# County of Fairfax, Virginia

RE: Interpretation for RZ/FDP 2004-PR-044, Tysons Corner Center; Phase 1 Elevated Plaza;  
Tax Map: 29-4 ((1)) 35A and 35C

**RE: Refinements to the Programming of the Tysons Corner Center Phase 1 Elevated Plaza**

**CORNER CENTER**  
PHASE 1: ELEVATED PLAZA

CD/IFDP PLAZA PLAN  
page 19

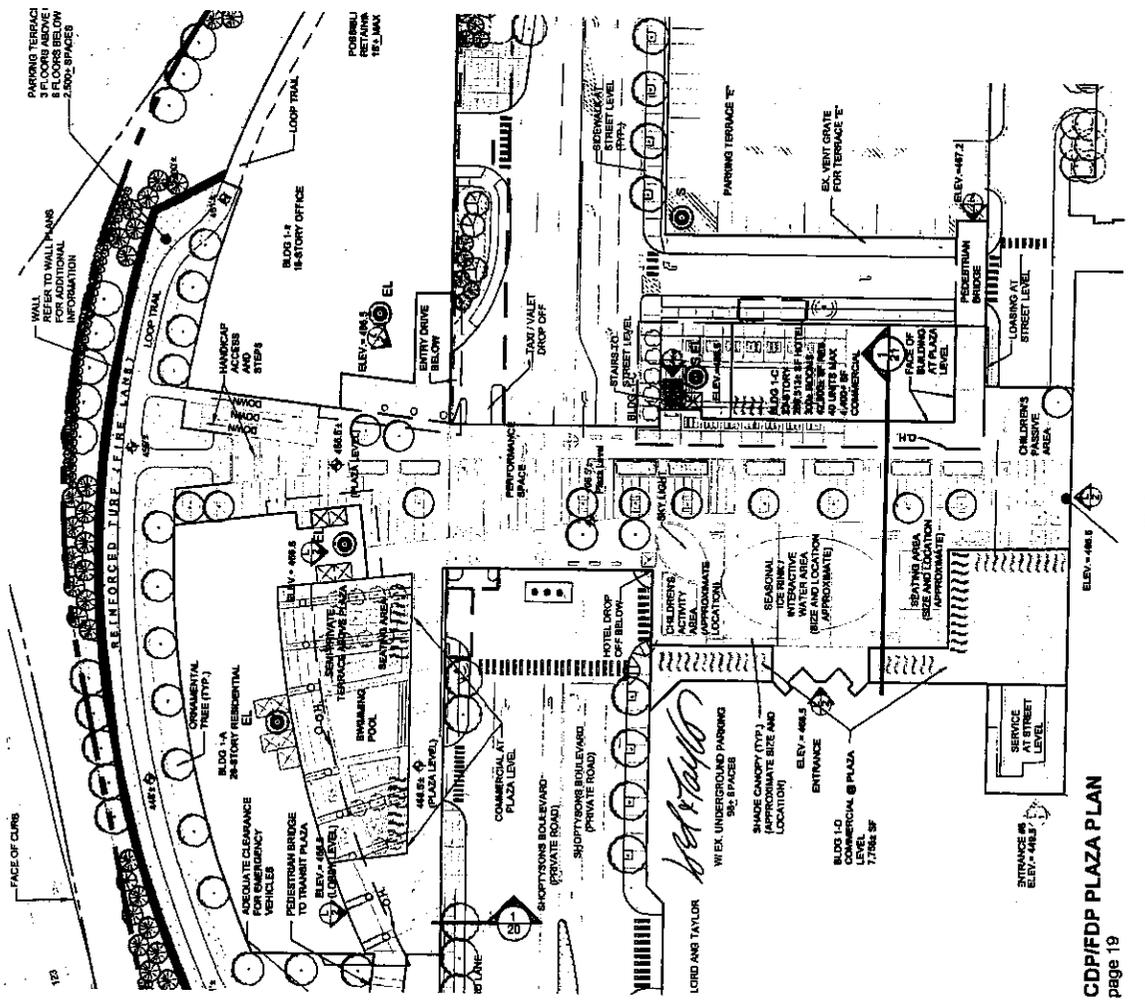
Macerich proposes to shift the location of the children’s play area to a more controlled space between Lord & Taylor and the Mall. In this location, parents can more easily monitor their children. This new location is further from the Plaza railing than it was shown on Sheet 19 of the CDP/FDP.

- Relocation of the children's play area to the southwest corner of the plaza.
  - Provision of a large active/passive area and outdoor rooms that can be utilized by adults and children for a variety of uses. These areas, along with the "passive lawn area" adjoining the children's play area, provide reading areas and space for children's entertainment in conformance with Proffer 52(C)(vi).

Enlarged Site Plan - Large Oval 8

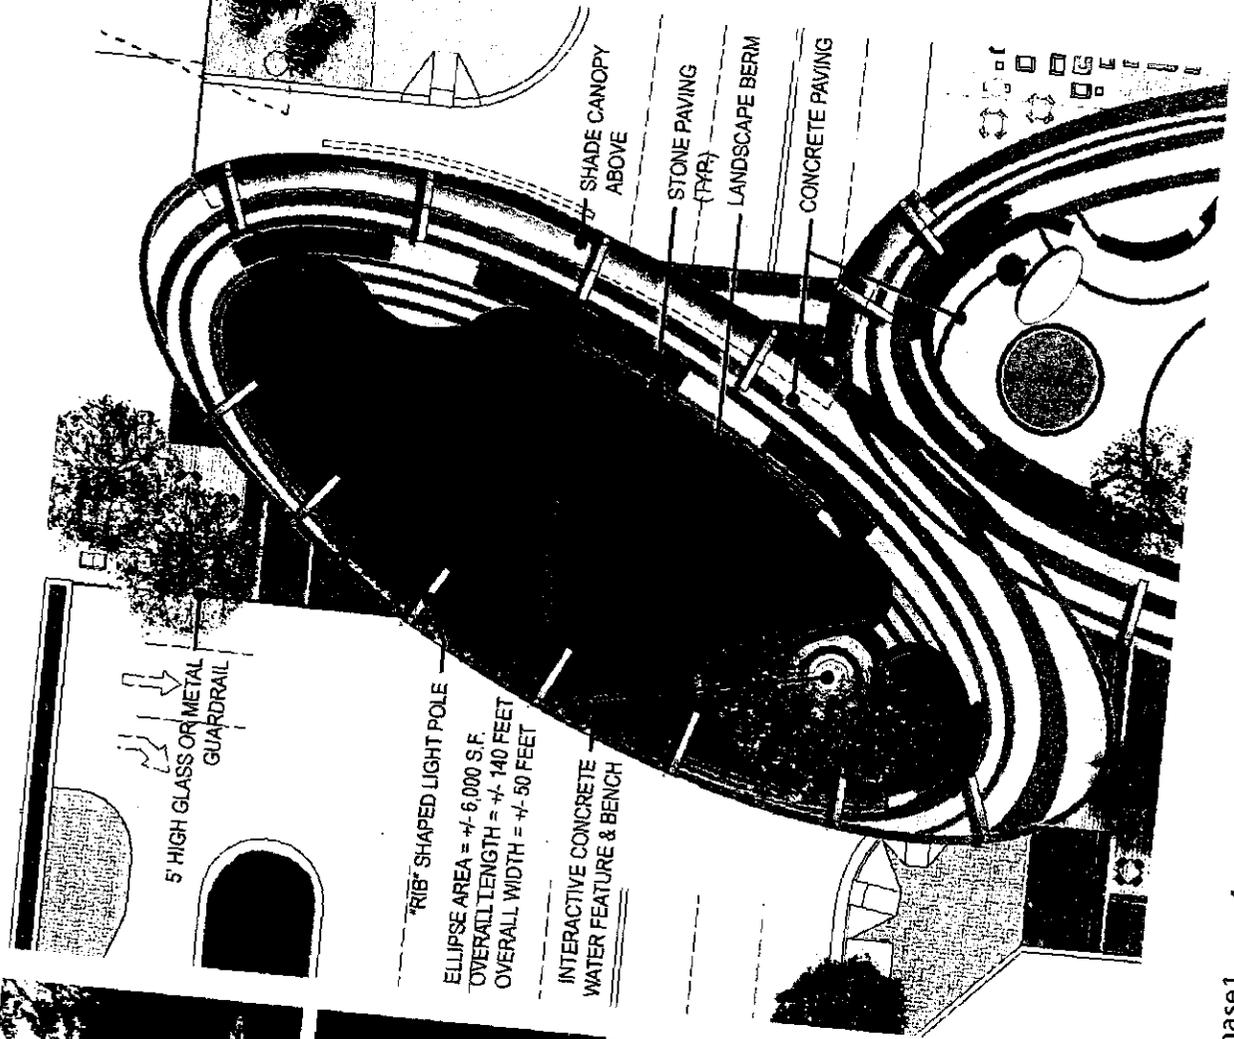
**Guardrails.** On the submitted plans, Page 9, titled Enlarged Site Plan – Small Oval, includes a note that the guardrail encircling the plaza will be five feet in height and composed of glass or metal. You have indicated in your September 4, 2012 e-mail, that the applicant requests the flexibility to provide a guardrail of less height. Most pedestrian related guardrails are less than five feet in height and the approved CDP/FDP and proffers do not stipulate a particular height.

I have just learned from our team that we are interested in making a tweak to the height of the guardrail around the plaza. Rather than indicating 5', we would like to have flexibility to provide less than 5' (still maintaining a safe height, of course, we may want to provide a 42" railing or something similar).

I don't think this is a proffer or cdp/fdp issue, but in the interpretation text and graphics, we indicated 5' for the railing height. Do we still have time to adjust the request? Or, in your response, assuming there is no objection, could you simply clarify that we can provide a railing up to 5'?

- Macerich has updated page 9 of the attachments to clarify information previously omitted from the drawing. The graphic now indicates “5’ High Glass or Metal Guardrail” to provide an accurate description of the materials that will be used for the guardrail.
- As a result of recent coordination with Lord & Taylor, Macerich proposes to permit, as an option, the use of lightwells along portions of the Lord & Taylor plaza frontage.

NO LIGHTWELLS

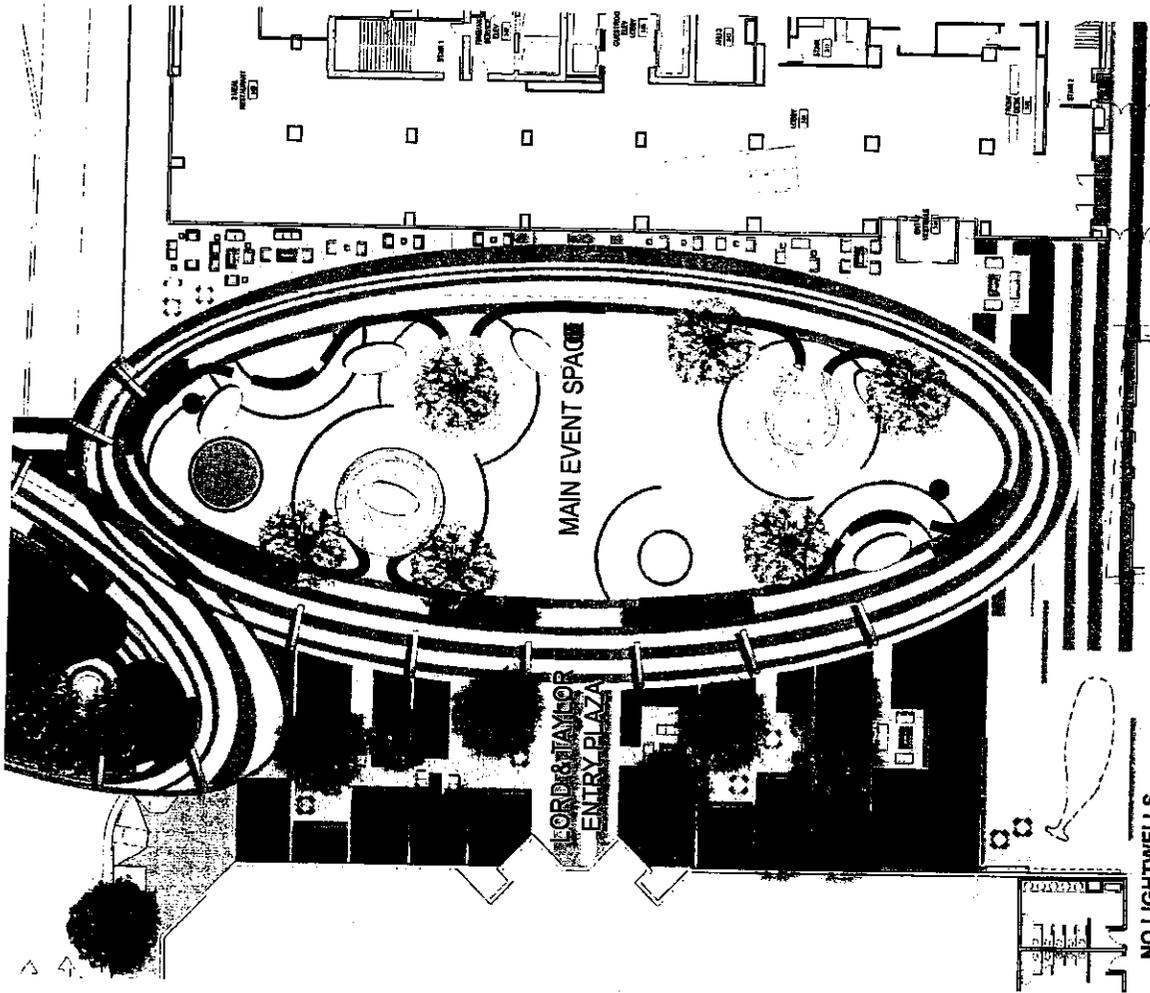
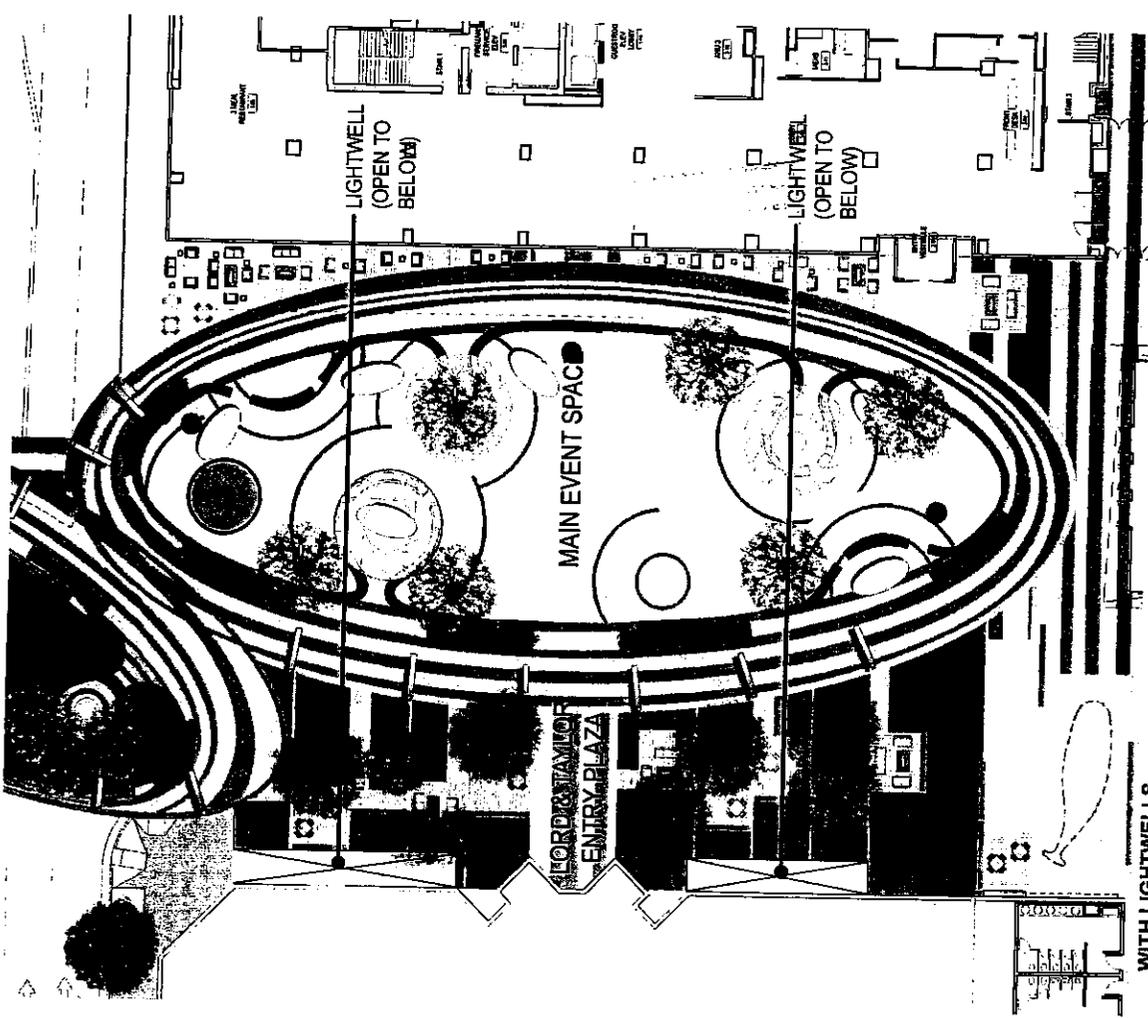
**Lightwells.** The proposed alternate design also includes an option to provide lightwells between segments of the Lord & Taylor frontage and the elevated plaza. If installed, these openings in the plaza surface would provide an open air connection to the at-grade development beneath the plaza. In addition, the lightwells would supplement the natural light that will be provided by the circular skylight proposed for the north end of the large ellipse.

Lord & Taylor, with frontage on the Plaza, has indicated a possible interest in providing lightwells between their building and the plaza. These lightwells would provide an open air connection between grade and the plaza along the Lord & Taylor building frontage.

Macerich seeks the ability to provide these lightwells or plaza offset from the building as an option should Lord & Taylor decide that this layout is preferable to the plaza flush with the anchor store along the length of the store frontage. Page 20 of the attached graphics package illustrates the footprint with and without lightwells.

- Ability to provide a seasonal ice rink on the plaza or provide a variety of amenities including, but not limited to, plaza accessible restrooms; outdoor rooms with seating, gaming tables, and a fire pit; a new mall entrance; flexible performance areas; mix of grass (natural or artificial turf) and hardscape surfaces; opportunities for outdoor café seating; and multiple paths of travel with activities integrated into the pathways.
